Departmental Comments		Applicant's Responses
A. Comments from PlanD		
<i>(Contact Person: Mr. Frankie Tsang, 2417 6255)</i>		
1.	As there will not be overnight stay as claimed, please critically review the need of providing 2 bedrooms inside the tent.	因應政府部門的意見，我們修訂了總綱發展圖(MLP)。申請修改為一個充氣帳篷，帳篷屬臨時充氣性質，將按家庭使用頻率及天氣狀況彈性展開或收起。充氣帳篷內部沒有任何間隔，不設睡房或留宿床位。

Response to Departmental Comments Table

Master Layout Plan (1:500)

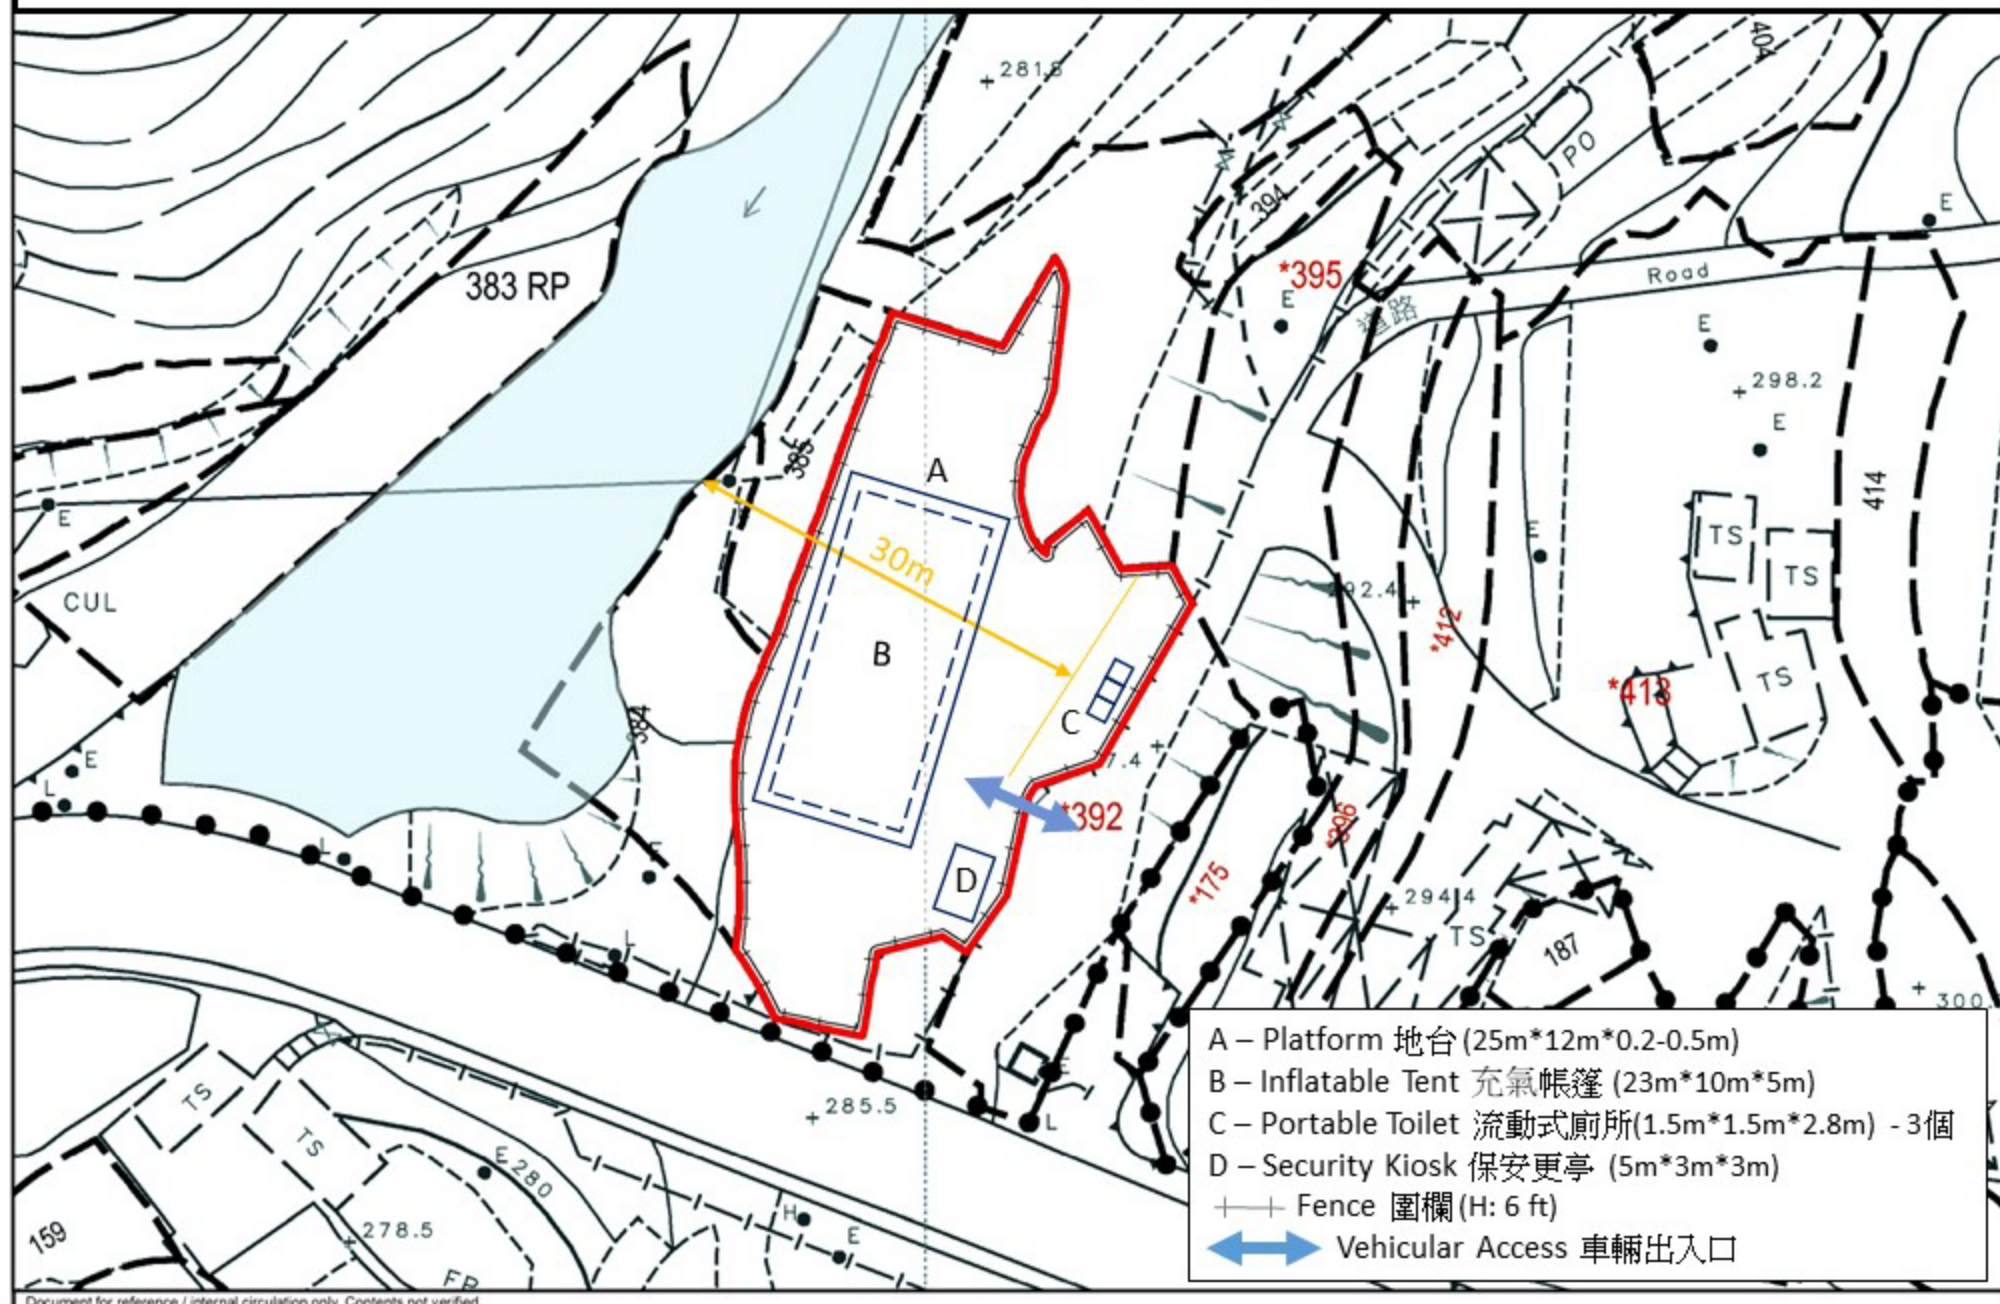
Departmental Comments		Applicant's Responses
<i>D. Comments from WSD</i> <i>(Contact Person: Mr. Jacky Wong, 2152 5746)</i>		
1.	Any portable toilet, if proposed, must be located at least 30m away from the nearest watercourse;	因應政府部門的意見，我們修訂了總綱發展圖(MLP)。了解，修訂後廁所的位置距離最近的集水區超過30m。已附上相關圖則於附件「B. Master Layout Plan_30m」。

o.	Demonstrate the proposed portable toilet with holding tank is located at least 30 m away from the nearest watercourse.	修訂後流動洗手間的位置距離最近的集水區超過30m。 已附上相關圖則於附件「B. Master Layout Plan 30m」。

帳篷的尺寸已修訂為長23米、闊10米及高5米，總面積較原設計縮減了23%。整個帳篷將架設於具透水功能的地台架上。設計方面，充氣帳篷四周由充氣支柱及大面積的PVC透視窗組成，內部不設任何間隔，保留全開放式空間。

取消原擬議的所有車輛停泊位，日後營地的交通安排將改為「只供上落客/貨」模式，車輛不會在申請地點停泊。

廁所的設置已作修訂：現改為三個流動廁所（尺寸為1.5米 x 1.5米 x 2.8米），並已遷移至距離最近集水區30米以外的位置。

保安更亭的尺寸已修訂為長5米、闊3米及高3米，總面積較原設計縮減了28%。保安更亭與流動廁所亦會架設於具透水功能的地台架上。

Location : Lot 386RP,387,388,389and392 in D.D. 433, Chueng Lung		Application No.: A/TW-CLHFS/5	
Figure No. : Figure 1	Figure Title : Sample of Tent	Scale : See Above	Date : 2026/09/02

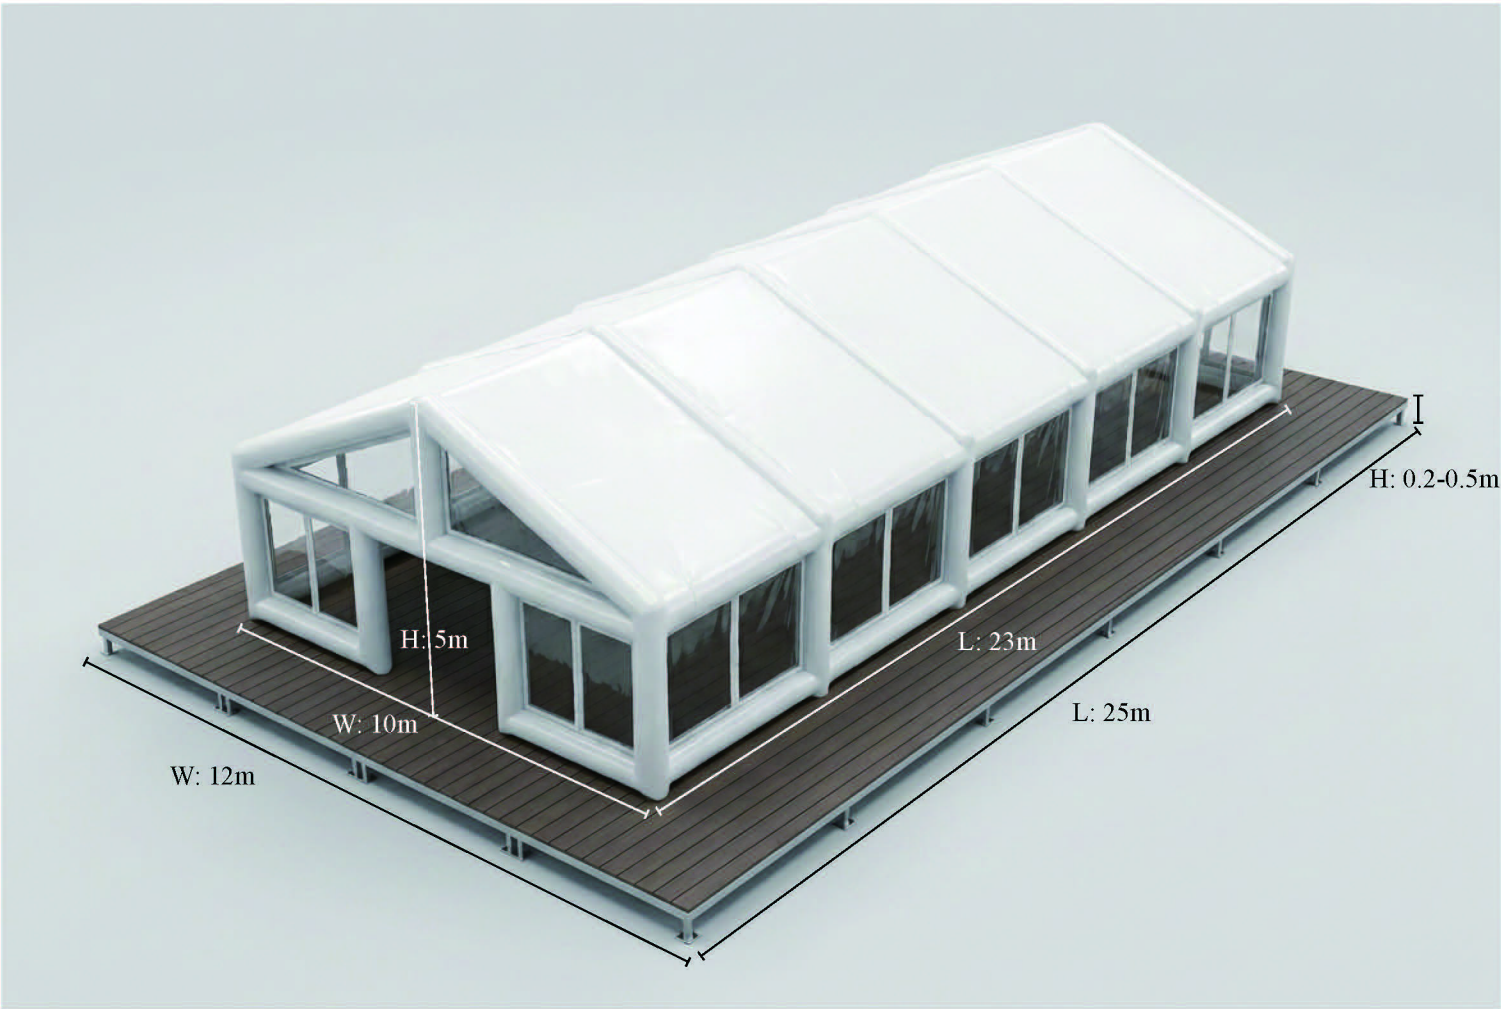
10.	Please improve the presentation of illustration photos for the proposed tent, portable toilet and security kiosk.	知悉，已修改有關充氣式帳篷、更亭及流動式洗手間之參考圖則。
<i>B. Comments from EPD</i> <i>(Contact Person: Ms. Jolene Wong, 2835 1844)</i>

帳篷 實物參考

地台 實物參考
